**Town of Windham
Major Site Plan Application
Comment Response**

**North Windham Public Safety
Franklin Drive
Windham, Maine 04062**

**RE: North Windham Public Safety Building – Major Site Plan & Final Plan Review
Franklin Drive, Windham ME; Tax Map 70, Lot 14**

On behalf of the Town of Windham, Sebago Technics, Inc., is pleased to submit this comment response letter and supplementary information in response to the Application Completeness & Staff Review Comments memorandum, dated July 2, 2026, for the North Windham Public Safety Building's Major Site Plan – Final Plan Review Application. The project site is located on the southeast side of Franklin Drive and can be further identified on the Town's Tax Map 70 as Lot 14. The comments from the Town are minor in nature, and project plans have been redlined for the revisions noted below. For reference, we have provided open staff and peer review comments *in italics* and offer our respective responses **in bold** below:

Public Safety Signage Markup

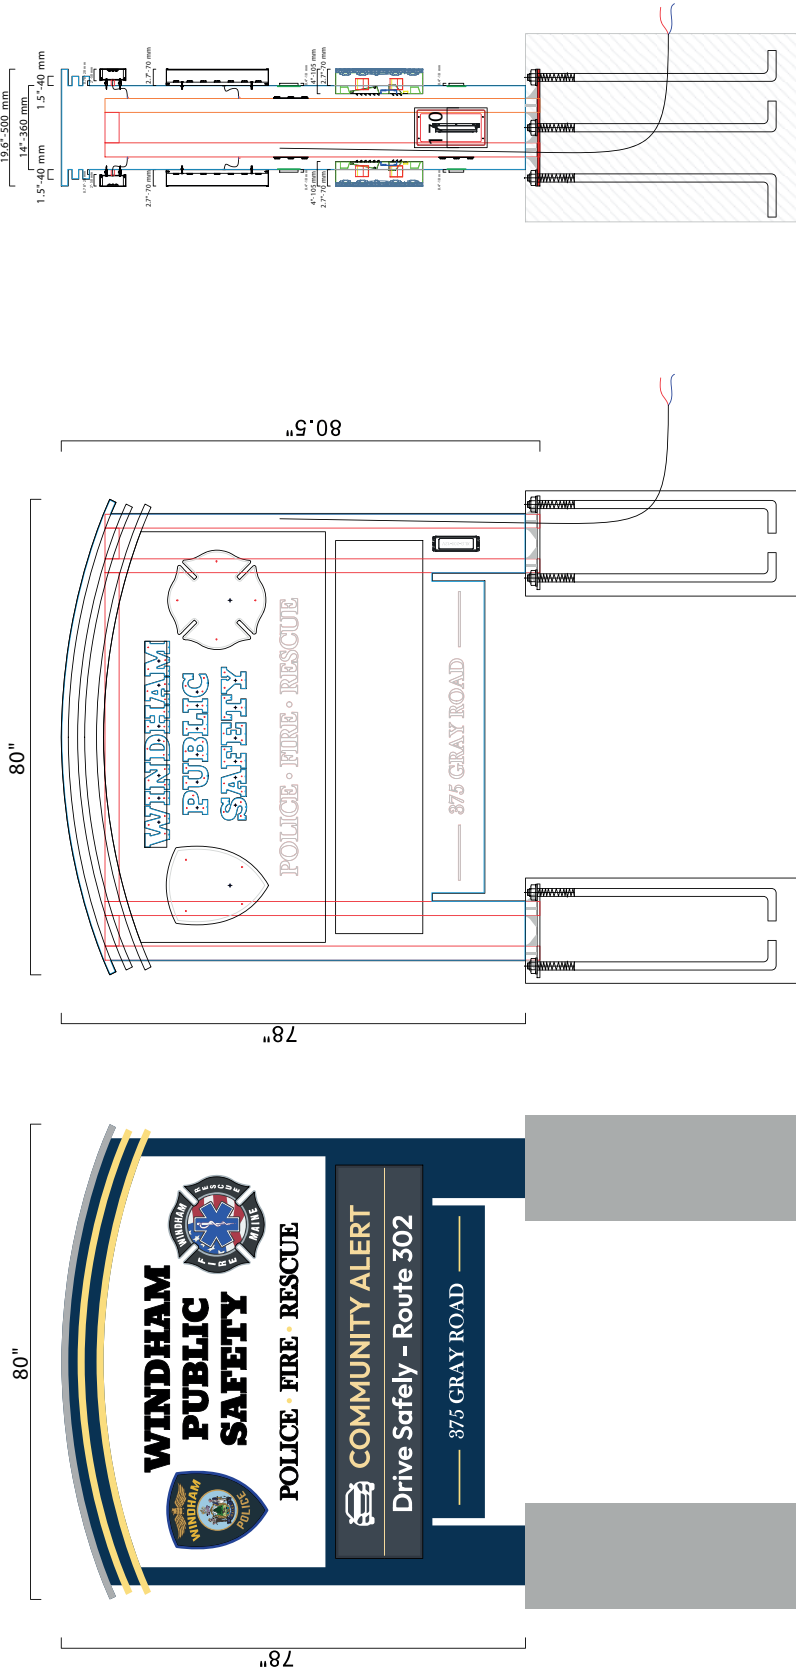
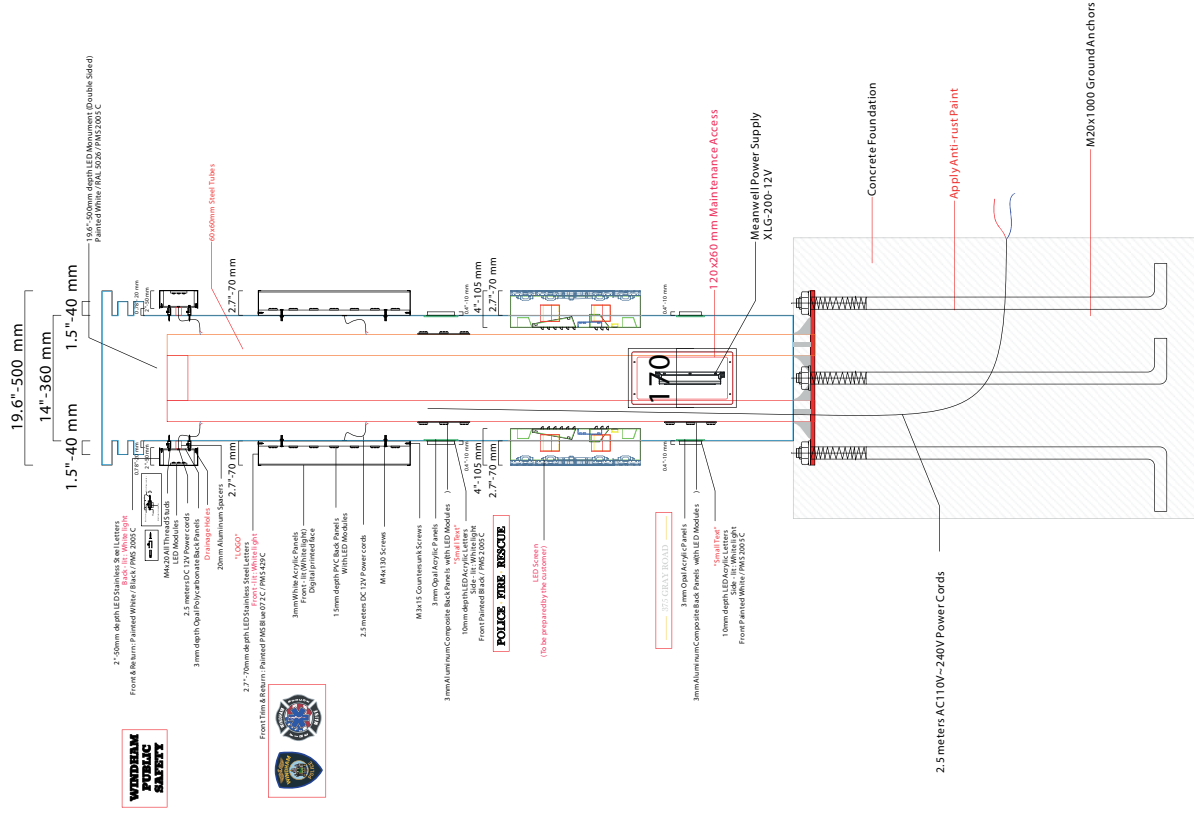
11. *Proposed freestanding sign (§120-811B(1)). Sheet C-103 shows a 5' x 15' concrete pad for a sign. The location, front view, materials, dimensions, and method of securing the proposed sign were not included. Please provide the sign exhibit, or confirm the sign will be permitted separately under Article 7.*

Revise
**NORTH
WINDHAM
PUBLIC
SAFETY**

Add Cumberland
County Sheriff logo

Add
***SHERIFF**

Response: Please see the attached sign exhibits depicting the proposed sign along Franklin Drive. The concrete pad has been removed as the sign shall sit on posts.
